Application for Works Approval

Works Approval Number W6901/2024/1

Applicant Talison Lithium Australia Pty Ltd

Premises Talison Lithium Mine
Maranup Ford Road
Part of mine tenements M01/6 and M01/4
As defined by the premises maps attached to the issued works approval

Figure 5 Hydrogeological cross section for TSF4

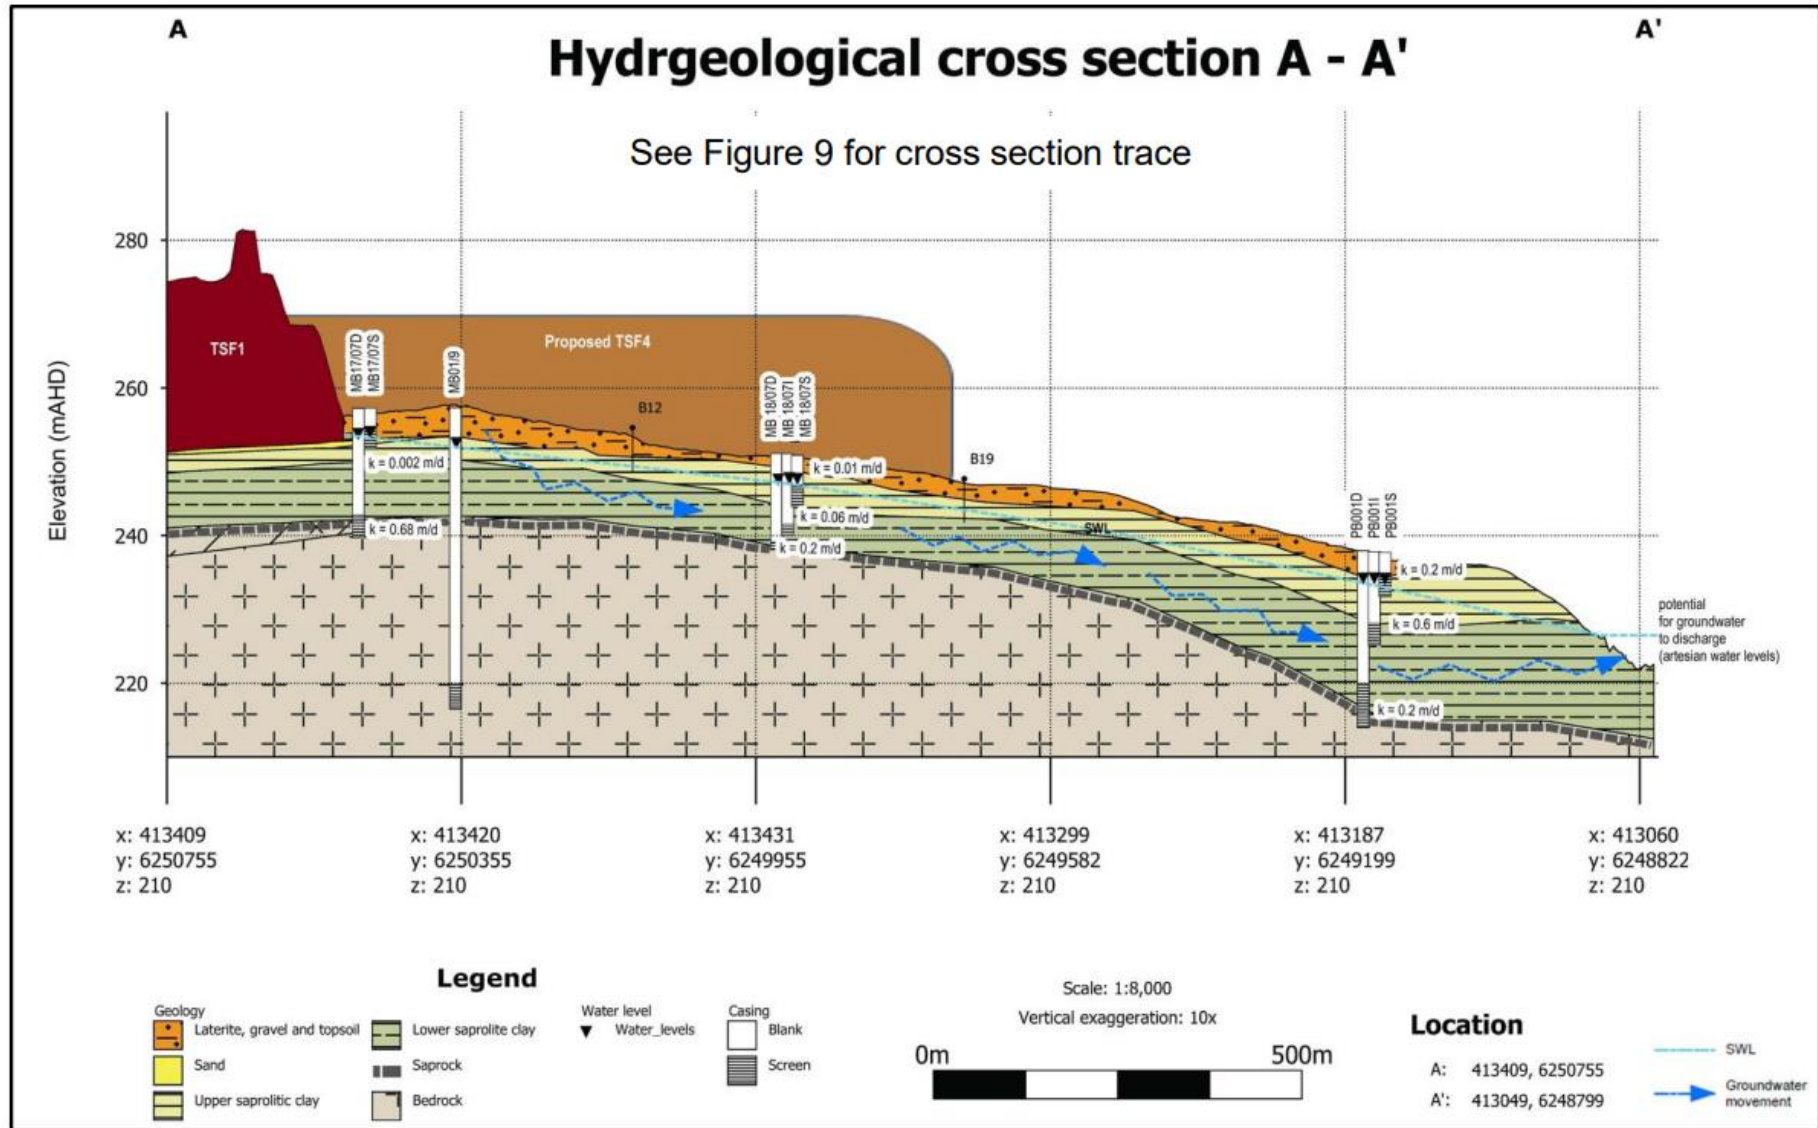
GHD 2022 state that seepage from TSF4 will flow predominantly in a southerly direction through saprolitic clays and underlying weathered bedrock⁷ (Figure 5). Approximately 80% of shallow and deep groundwater is expected to flow with topography and discharge in a southerly direction into the upper catchment of Woljenup creek. GHD 2023c state that groundwater may discharge into Woljenup creekline approximately 750 m down gradient of TSF4. A smaller component of seepage, around 20%, is inferred to migrate to the north-west towards tin-shed dam.

Although the use of slug tests to measure hydraulic conductivity is a useful technique in some situations, this method of testing only provides an estimate of hydraulic conductivity of regolith within a few metres of each tested borehole and cannot provide estimates of this parameter at larger scales. For this reason, the estimates of hydraulic conductivity of saprolite and the saprock aquifer may not be correct at a broader scale in the subsurface near TSF4 – they are also not consistent with measurements made in these materials in the region by some other studies. Other studies on groundwater recharge to aquifers in granitic weathering profiles have indicated that the only effective way of identifying the effects of recharge through preferred pathways in saprolite is by using regionally extensive water-balance assessment methods (i.e. as referred to in Cuthbert and Tindimugaya (2010) and Grigg and Kinal (2020).

It is also considered unlikely that preferred pathways through clayey saprolite would be detected in a standard drilling investigation (as undertaken by Talison). This is because their density in the landscape is very low (about 1% of a horizontal surface at a depth of 6 metres – refer to Dell *et al.*, 1983). Consequently, it would be highly unlikely that a borehole would penetrate an old root channel. Even if a borehole were to directly penetrate an old root channel, it would not be detected due to clay smearing during drilling.

Given the uncertainty regarding the hydrogeological investigations and subsequent conceptual model developed by Talison, it is important that these consider the possibility that the hydraulic characteristics of the weathered granitic profile could be similar to results obtained from other studies in the region. The delegated officer will consequently take a precautionary approach to the assessment of hydraulic conductivity and potential seepage pathways and considers that hydraulic conductivity and the potential for seepage pathways may be higher than indicated by GHD and Talison.

Figure 11: Location plan of existing (white) and proposed (green) groundwater monitoring bores. Locations in pink are those proposed for installation at a later time if required.

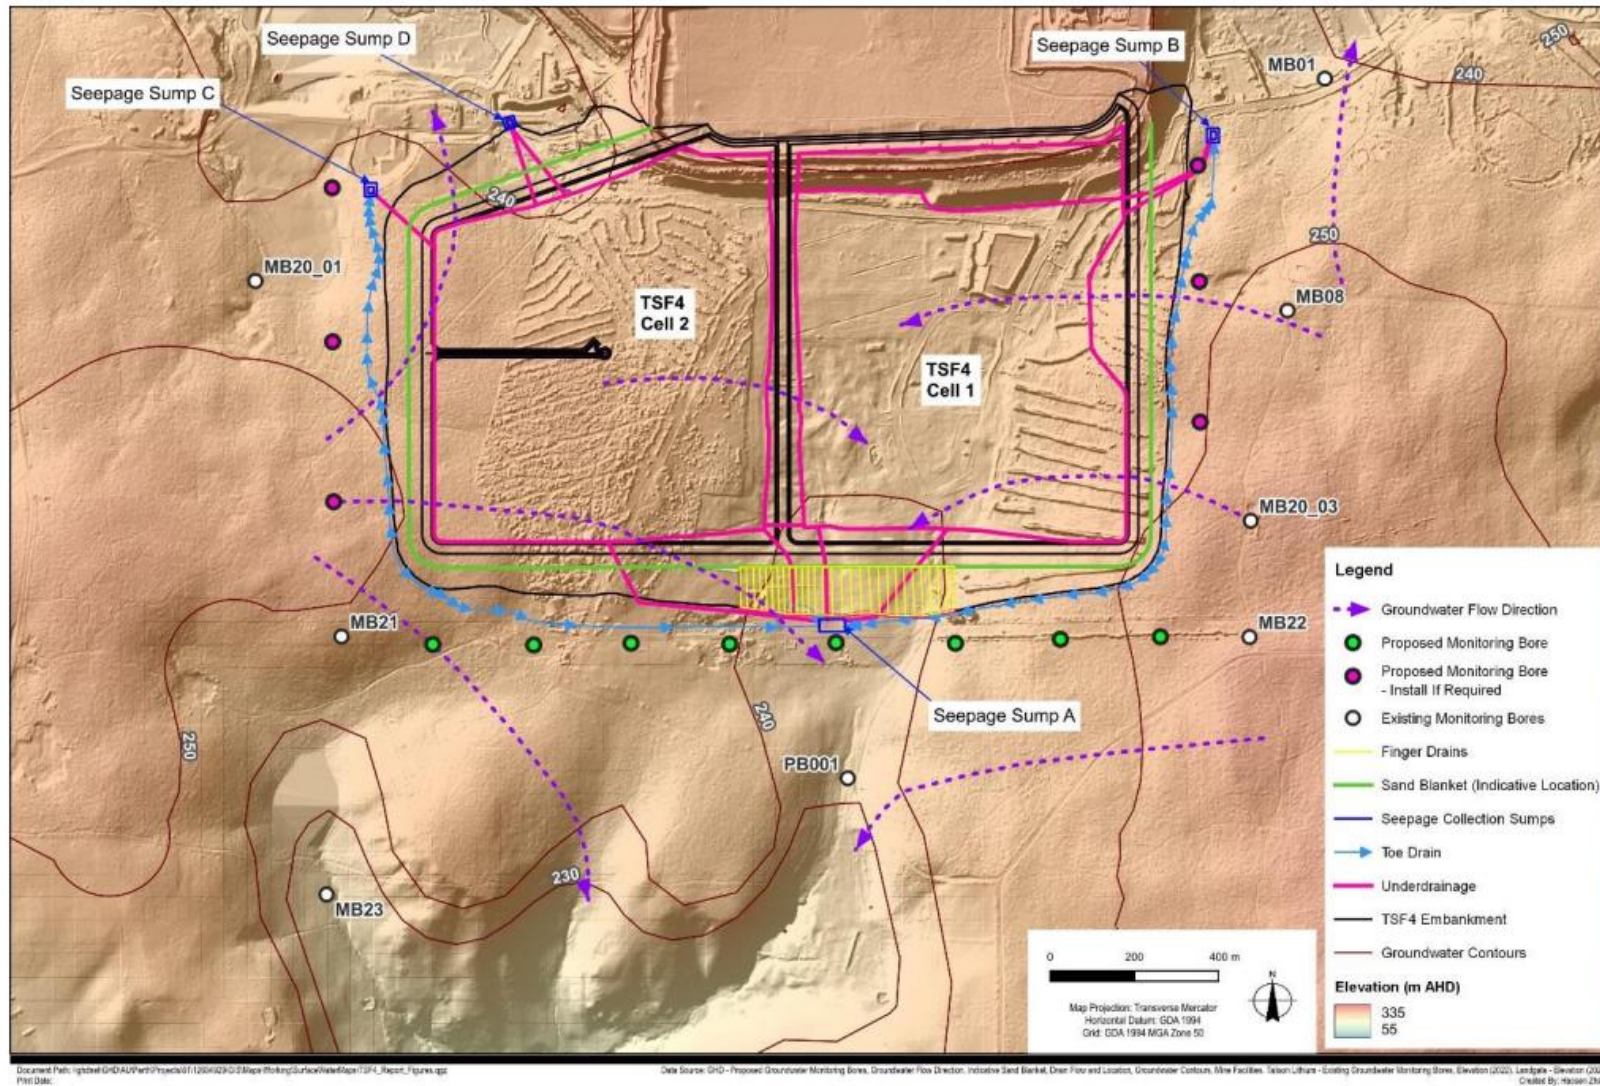
- Installation and monitoring of TSF4 perimeter bores (Figure 11) for field parameters, contaminants of concern and major ions (Table 20 in Appendix 3). These will comprise shallow, intermediate and deep bores at locations along the southern embankment of TSF4. Talison advised DWER during this assessment that they had commenced installation of these bores.

Figure 12: Proposed surface water and sump monitoring locations

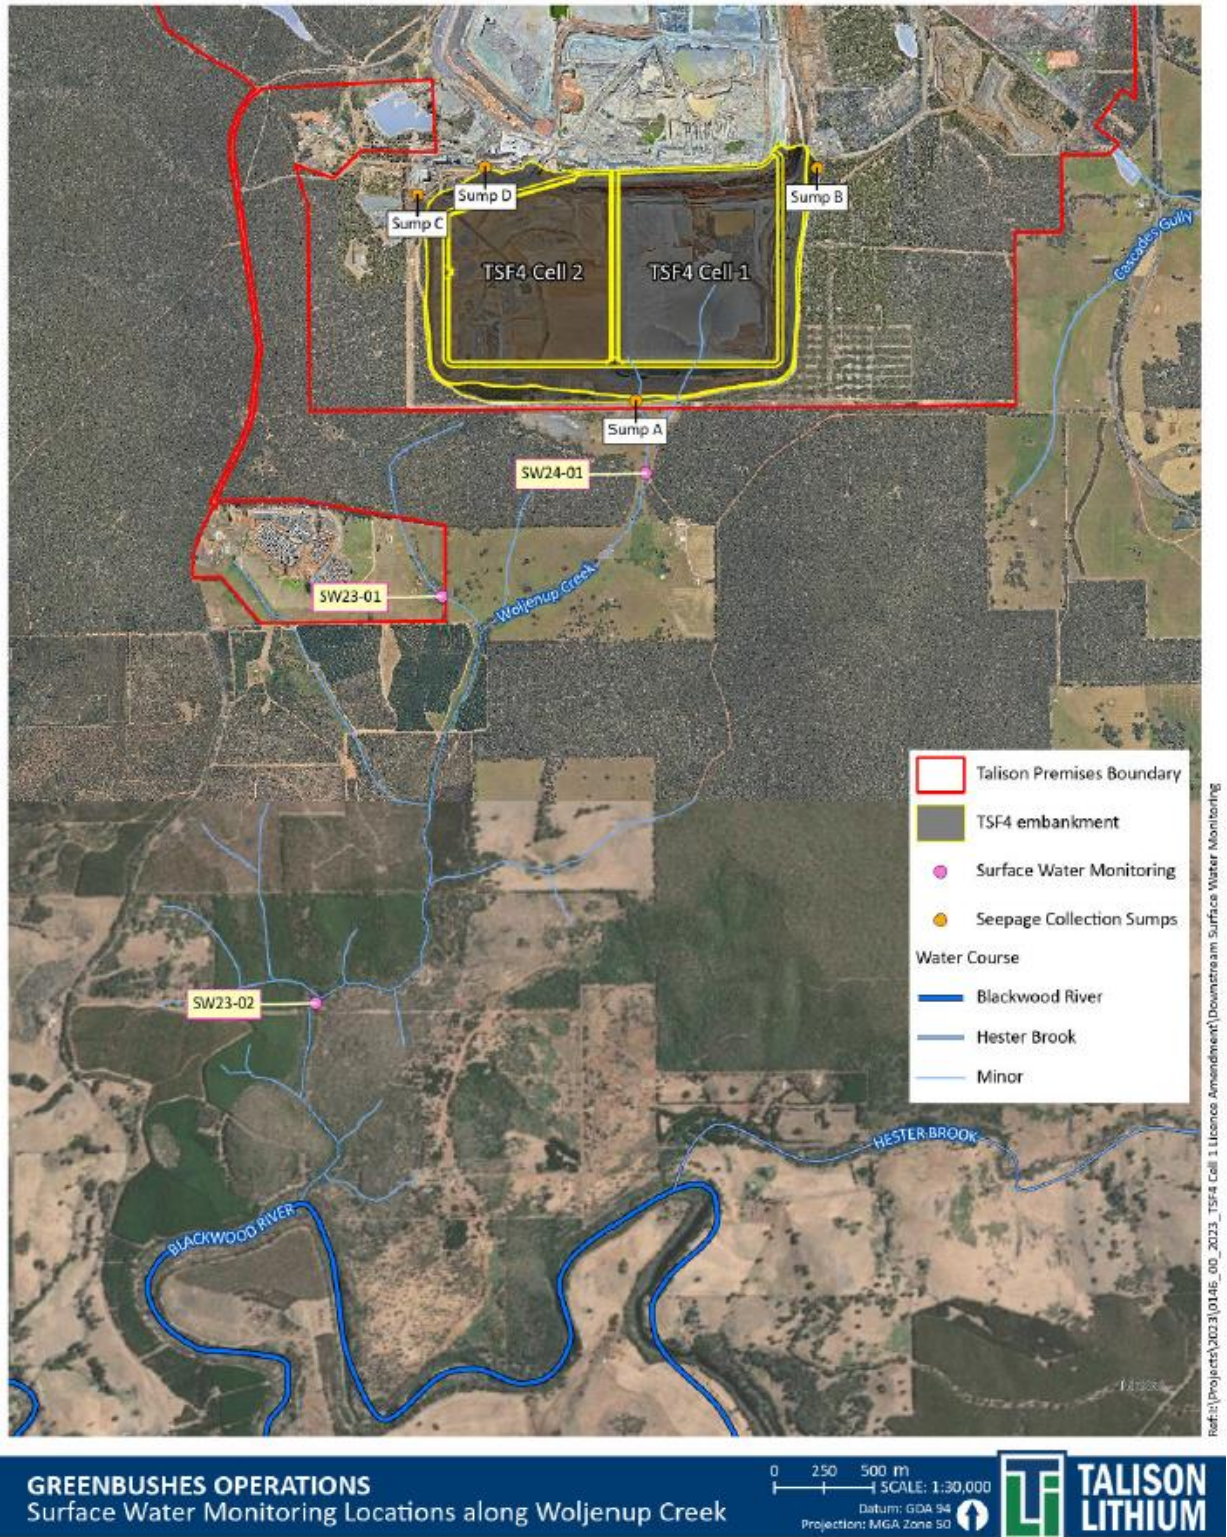
- Monitoring to the north of Jones Dam¹⁰ (SW24-01) and two additional monitoring points (SW23/01 and SW23/02) along Woljenup Creek (Figure 12) for field parameters, contaminants of concern and major ions (Table 25 in Appendix 3)
- Data will be compared to “trigger values” (Table 26, appendix 3), which trigger further

- quality of the drainage the sumps (A, B, C & D) (Figure 12) including field parameters, flow rates, contaminants of concern (metals) and major-ions; and
- monthly to bi-annual monitoring in the year following commencement of operations (including time limited operations), with subsequent monitoring occurring less frequently (quarterly to annually).
